SERVICE BULLETIN

24.08.06

Following reports from the field regarding failures of TSE disc type springbrakes, it has been discovered that not all drainage plugs are being removed from new brake chambers when fitted to axles.

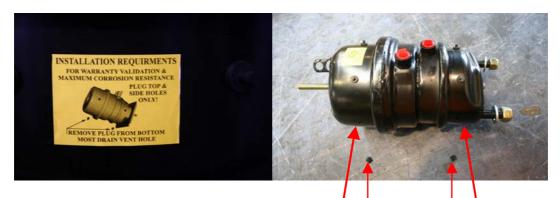
Chambers are shipped with all drain holes plugged as it is not possible to know final chamber orientation until fitted. Once fitted, the lowermost plug on each section, <u>must be removed.</u> Failure to do so invariably results in premature failure of the chamber.

Photos below show the label attached to each new chamber reinforcing this requirement, and location of plugs referred to. This requirement also applies to service chambers.
